ADDENDUM NO. 02

Indiana University – VanNuys Med Sci Bldg – MS Labs Phases 1-2 Renov

IU Project No. 20240023

July 15, 2026

QL012

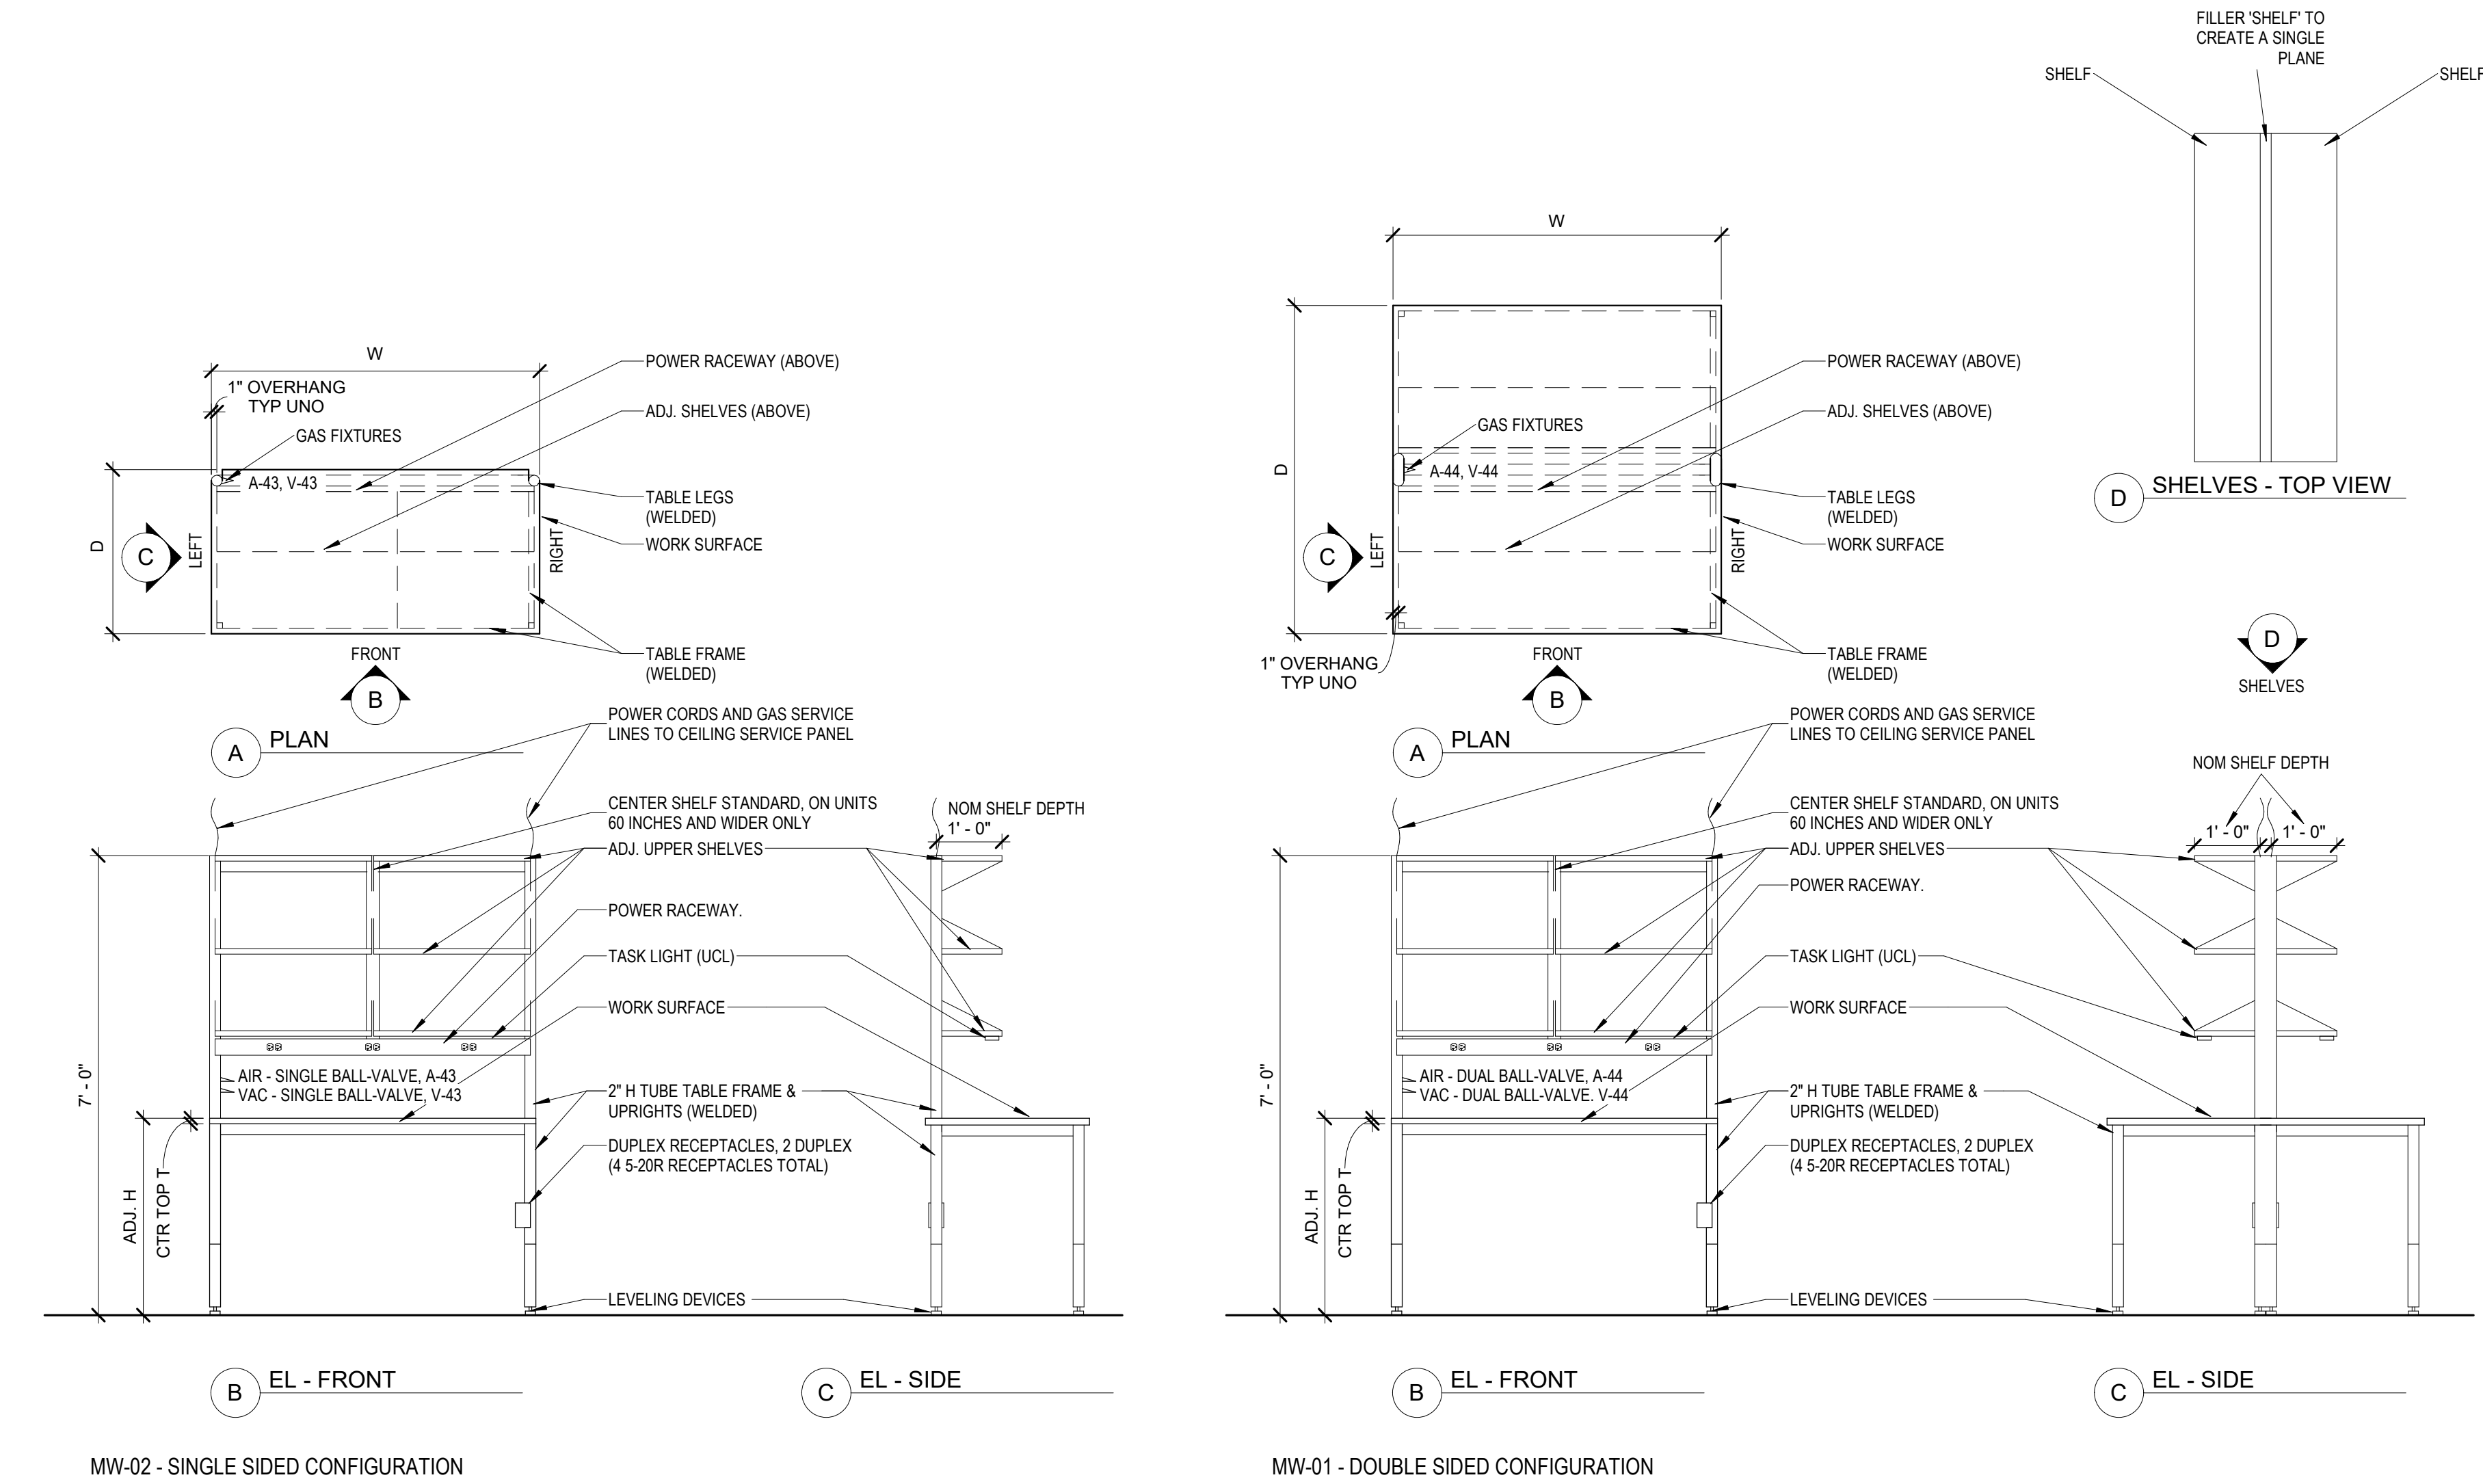
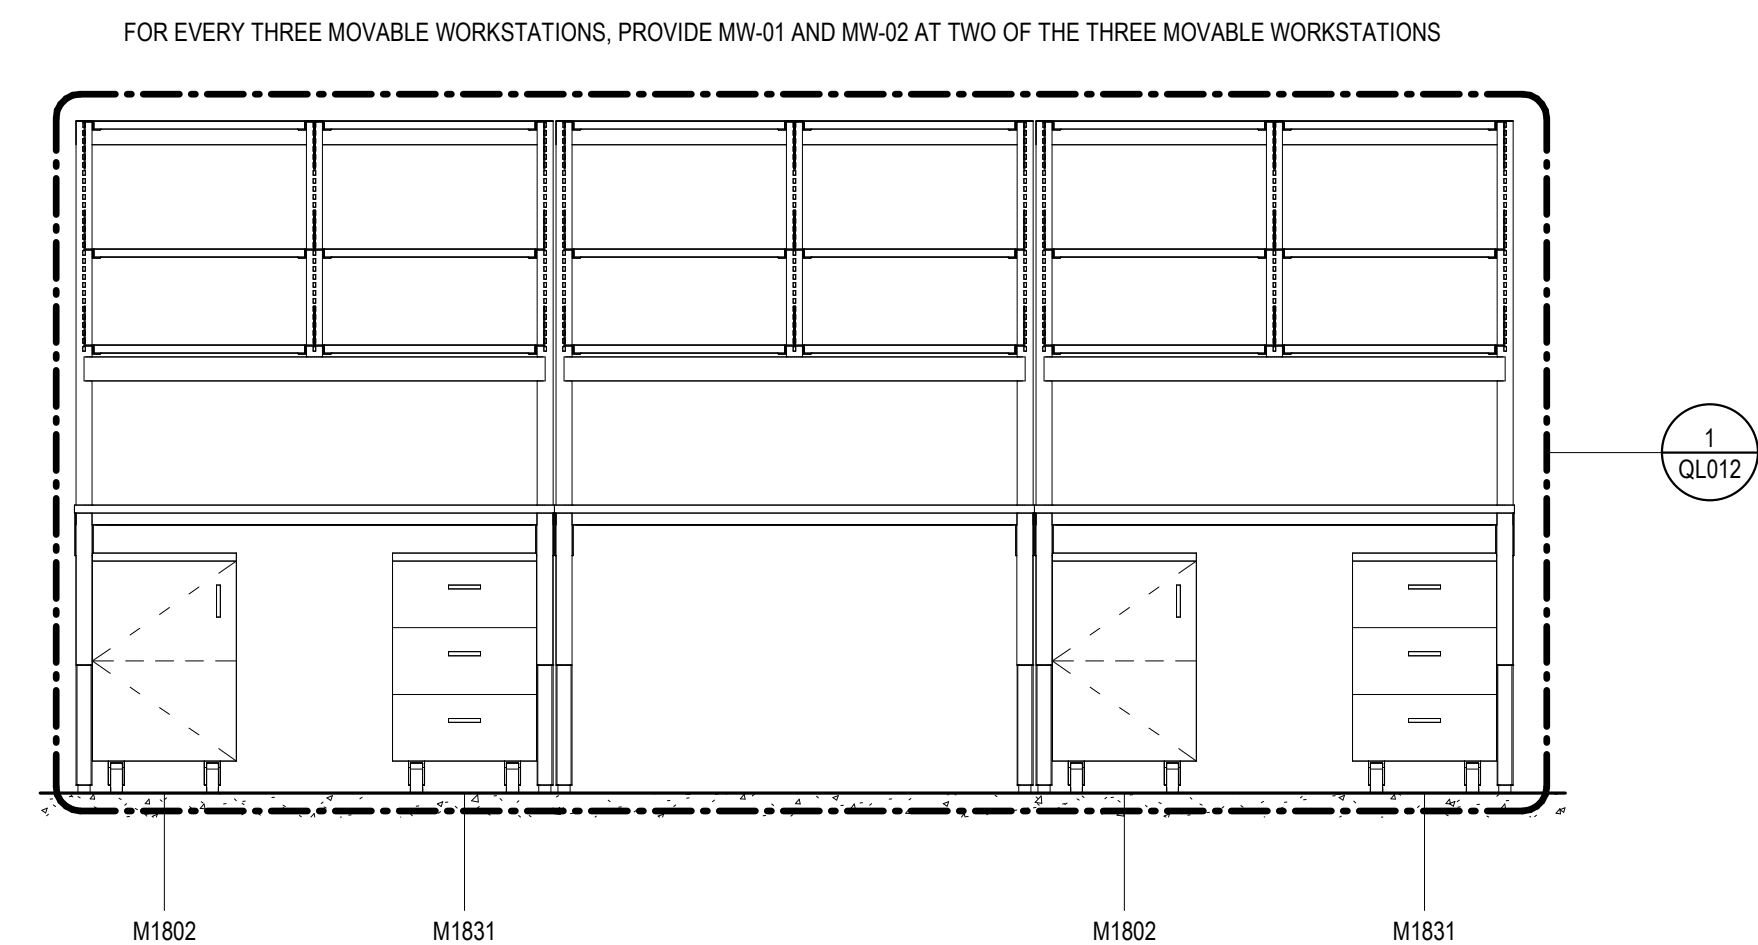
<u>ITEM</u>	<u>LOCATION</u>	<u>DESCRIPTION</u>
		d. 2.07, B. Shelf Edge Protection. 1. Retaining Rod Clarification: Regardless of what is detailed on Sheet QL012, retaining rods are required at the front edge of all workstation shelving. 2. Retaining Rod Clarification: Per 1/QL012, Detail – Moveable Workstation the area between the two shelves should have a filler shelf between them so that the two shelves plus the filler shelf create a flat plane. This allows larger items to span between shelves. Because of this configuration, rear lips are not required. e. 2.10 G Casework Locks – remove the word “wood” and replace it with “plastic laminate clad casework cabinets.” Section now reads: “G. Locks: Cam type with five-pin tumbler, brass with chrome-plated finish; complying with BHMA A156.11, Type E07281 (metal and wood plastic laminate clad casework cabinets), E07111 or E07021 (metal cabinets).” f. 2.10 G 4 – Casework Locks - section added - 4. Provide locks at all casework doors and drawers except not at sink door cabinets. g. 2.11 Laboratory Work Surfaces clarification: On Sheet QL001, lab furnishing and equipment general notes , Item C reads: “Lab casework at lab perimeter walls shall be plastic laminate clad casework, UNO. Casework under fume hoods shall be metal, UNO. Adjustable shelving shall be metal, UNO. Moveable casework and workstations shall be metal UNO. See QL012 for more information on moveable casework.” Item D reads: “Lab counter tops shall be 1" thick phenolic, UNO.” On Sheet QL012, Laboratory Moveable Workstation Schedule indicates that the work surface material is to be phenolic. On Sheet QL012, the detail for the mobile cabinets indicates that the countertops on the top of the mobile cabinets will be ¾" thick phenolic tops. h. 2.11 C – Plastic Laminate Tabletops - section deleted C. Plastic Laminated Tabletops (at Moveable Workstations): Fabricate with cutouts for accessories as needed, and butt joints assembled with adhesive, type per manufacturer and concealed metal splines. 1. Top Configuration: Flat, 3/4 inch (19 mm) thick, with beveled edge and corners, and with drip groove 1/2 inch back from edge.

P212a

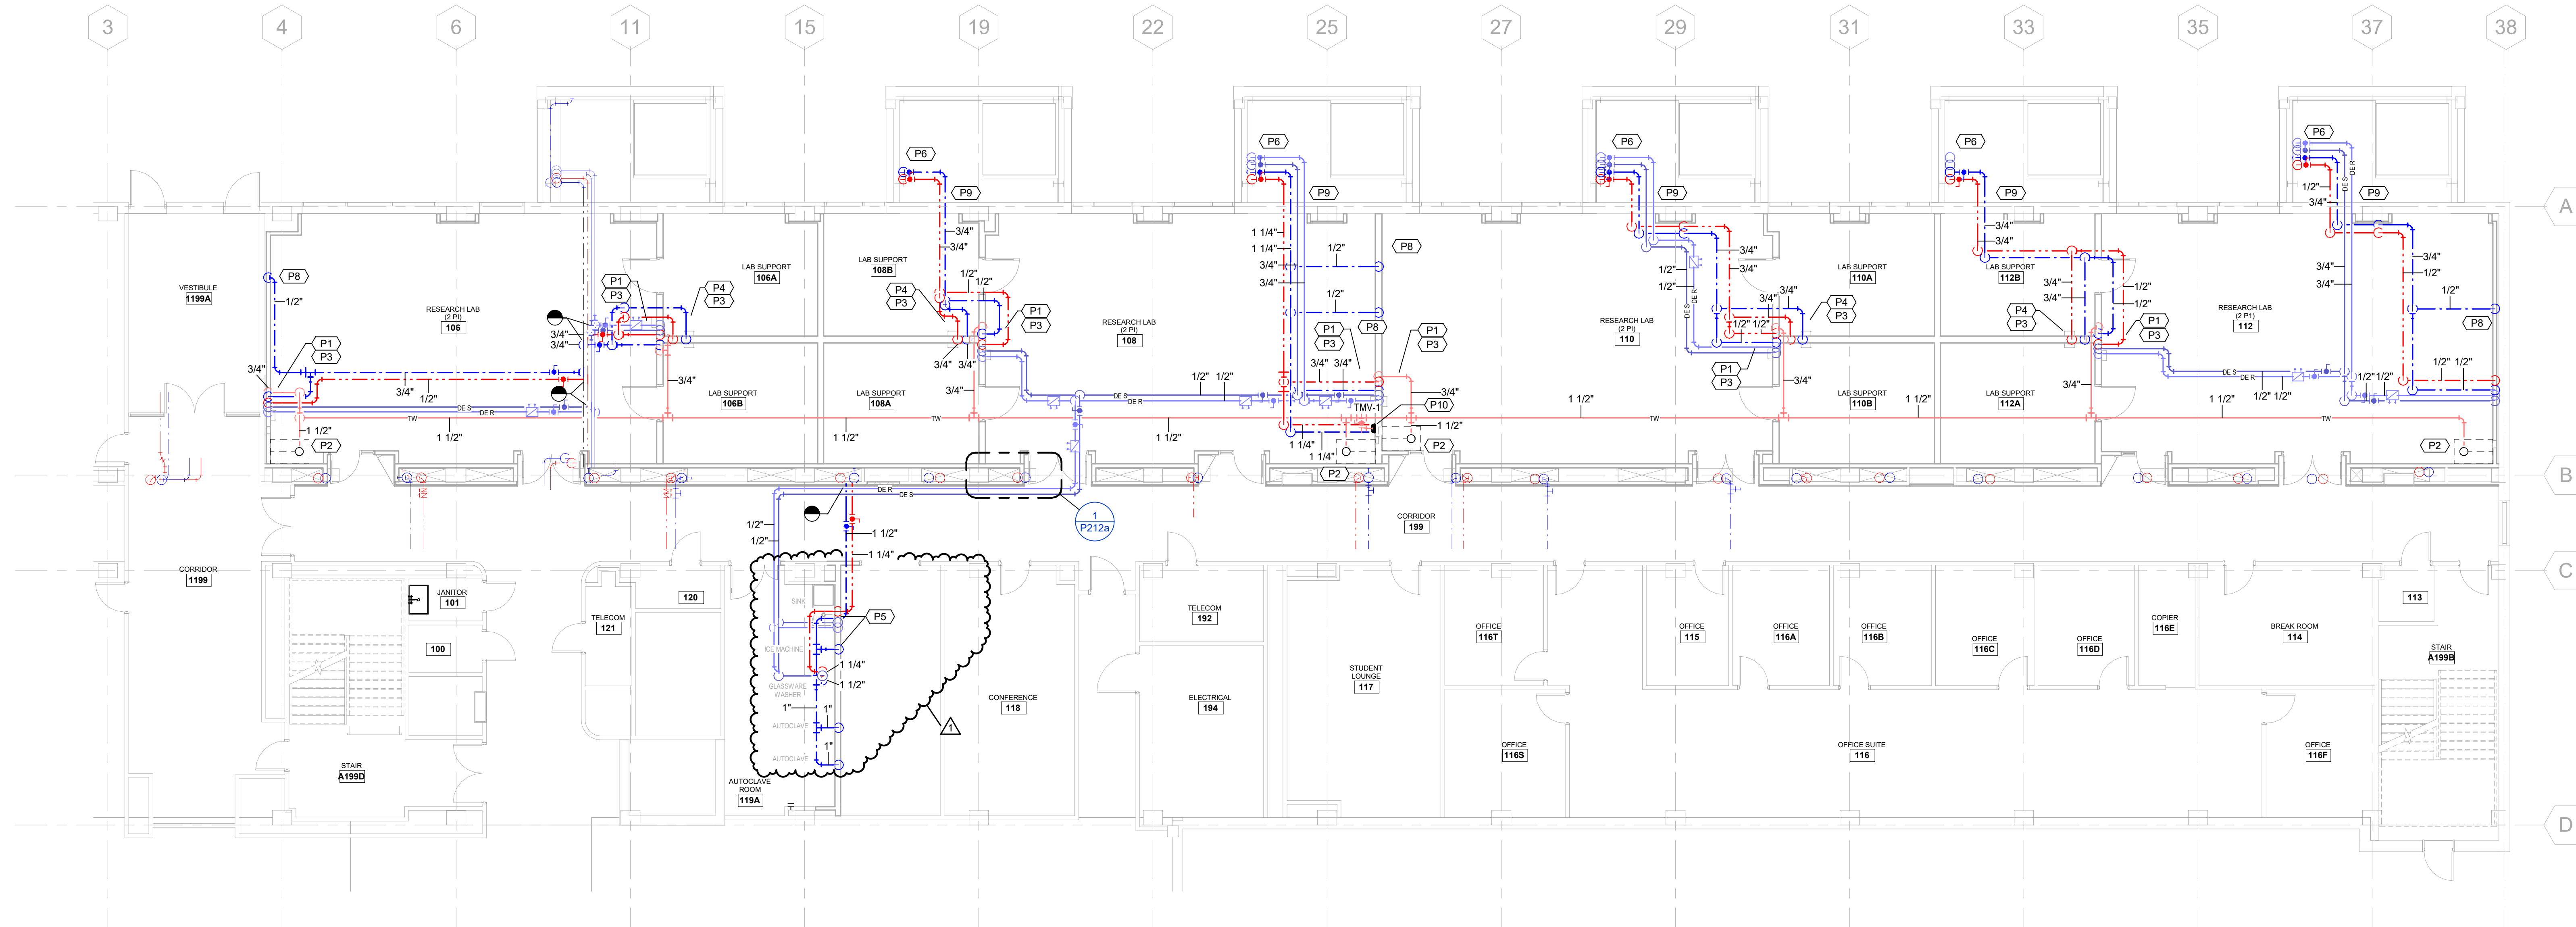
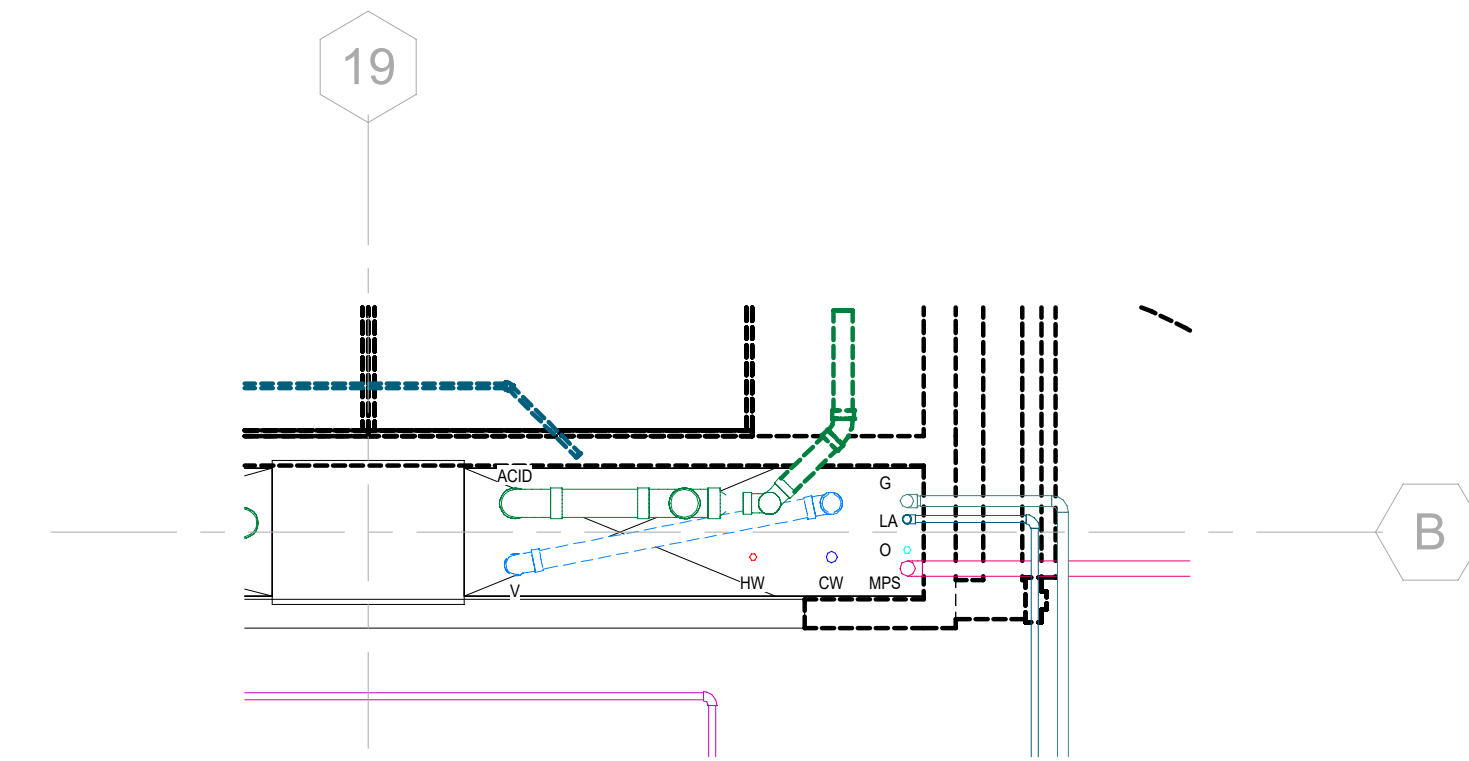
<u>ITEM</u>	<u>LOCATION</u>	<u>DESCRIPTION</u>
2.7	Drawings Sheet P212a	Adjusted plan notes and tags to better reflect equipment responsibility in Autoclave Room 119A.
